FPL Energy
Seabrook Station

SBK-L-06059
Docket No. 50-443

Seabrook Station
License Amendment Request 06-03
“Application for Amendment to the Technical Specifications
for Miscellaneous Changes”

Subject: License Amendment Request 06-03, Application for Amendment to the Technical Specifications for Miscellaneous Changes

PID- 1-SW-B20794

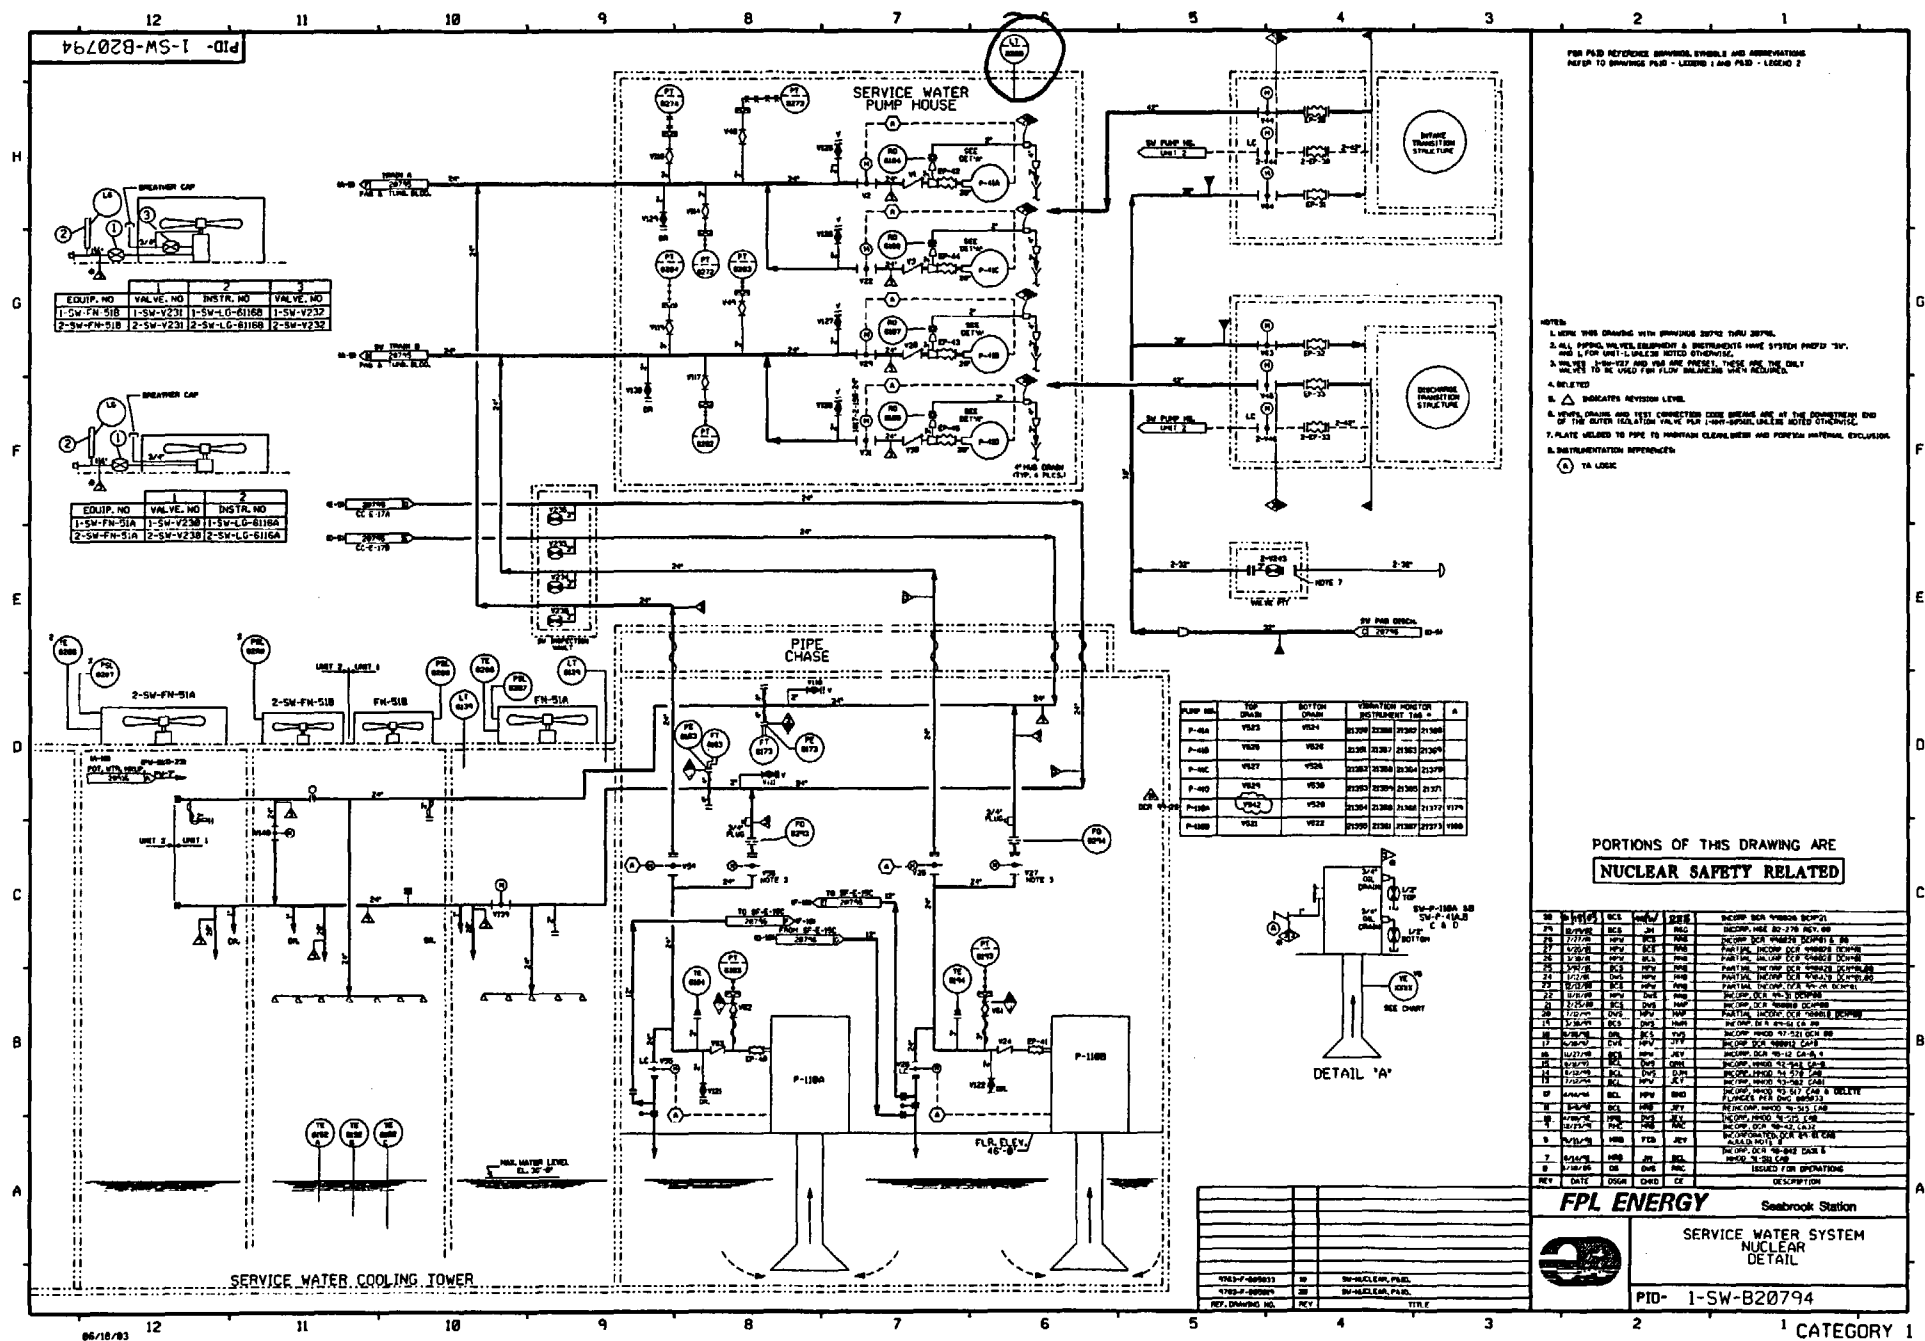
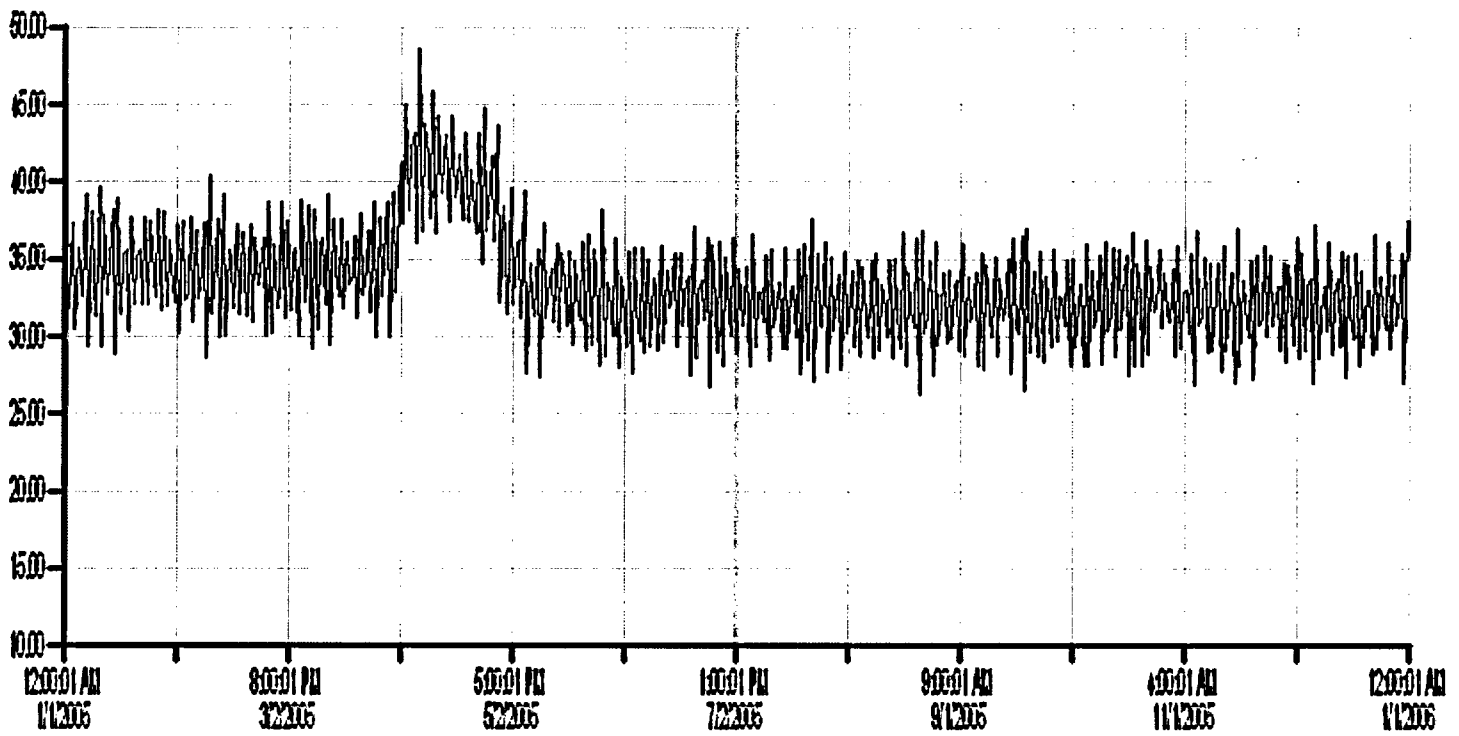
TS Surveillance Requirement 4.7.4.3 calls for the service water pumphouse water level to be verified at or above 5'0" (-36'-0" Mean Sea Level) at least once per 24 hours. This level is not adequate to support service water pump operation and is therefore not correct. The inadequate level stated in the surveillance was identified in 1997 and administrative controls put in place to verify adequate pumphouse water level. The Control Room TS log has operators verify, daily on the Operations TS Logs, that the service water pumphouse level is greater than 25 feet.

Calculation 4.3.08.72F, Attachment 1, indicates (page 133) that the minimum service water pumphouse level to support service water system operation is (-)15.9' Mean Sea Level (MSL). Calculation 4.3.08.36F indicates (Appendix A, page 4) that the 0' indication for this instrument is (-)41' MSL. The required indicated level is therefore 41' (*i.e.* MSL) - 15.9' = 25.1'. The proposed change corrects the minimum pumphouse level error.

3/4 7-13A	In Surveillance Requirement 4.7.4.3, replace 5'0" (-36'-0" Mean Sea Level) with 25.1' (-15.9' Mean Sea Level).
